M.I.T Apparel (Extension new 5 storied building)

9th June 2021

1. **Extension new 5 storied building** (five storied (G+4) reinforced concrete structure)

Floor layout plan

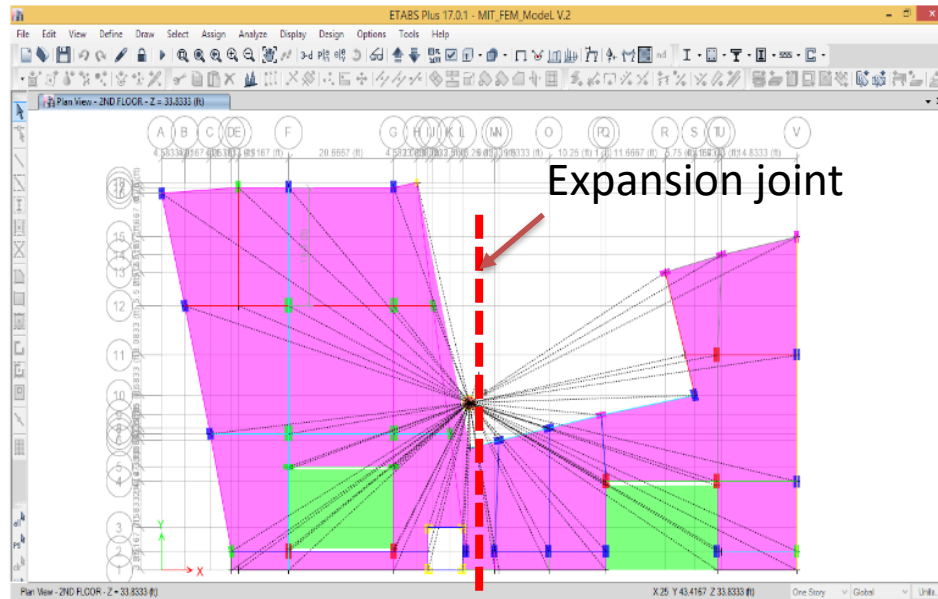
The building is geometrically irregular shaped. Due to lateral forces the building might be affected for torsional irregularity. Building engineer is required to check the torsional effect of the building due to lateral forces. Also design report is required to prepare in compliance with section 1.9.1.1 and section 1.9.1.2 as per BNBC.

ETABS output

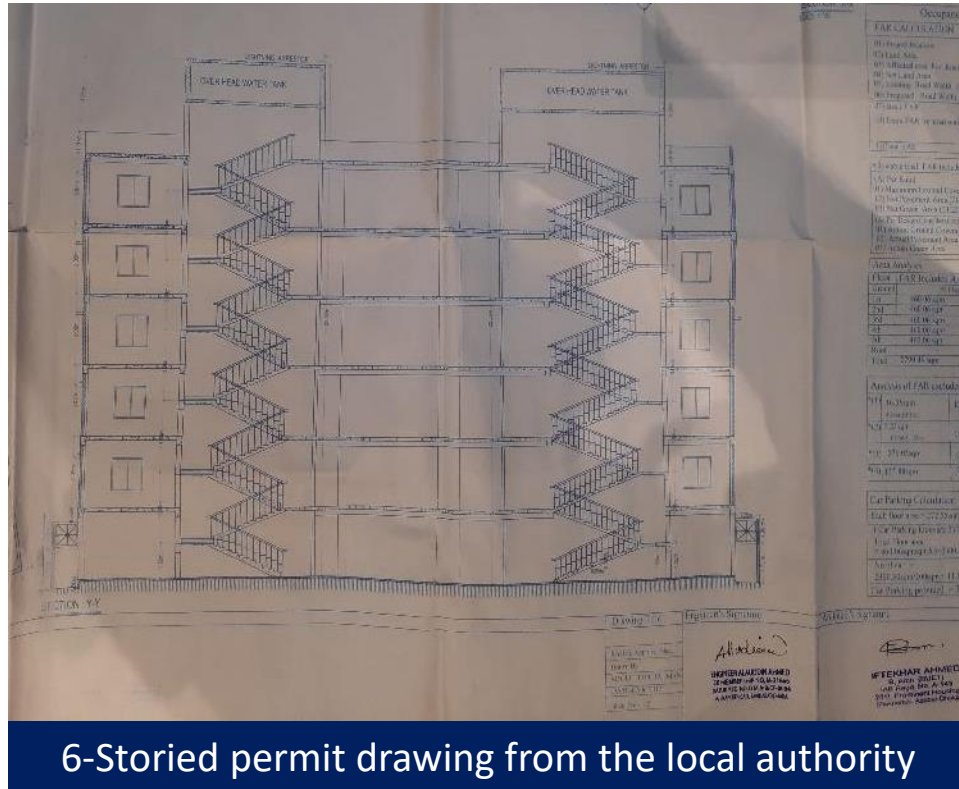
Expansion Joint (1st & 2nd floor only)

Expansion Joint exist on 1st & 2nd floor but in software-based analysis expansion joint is not considered. Single diaphragm is assigned for distribution of lateral forces.
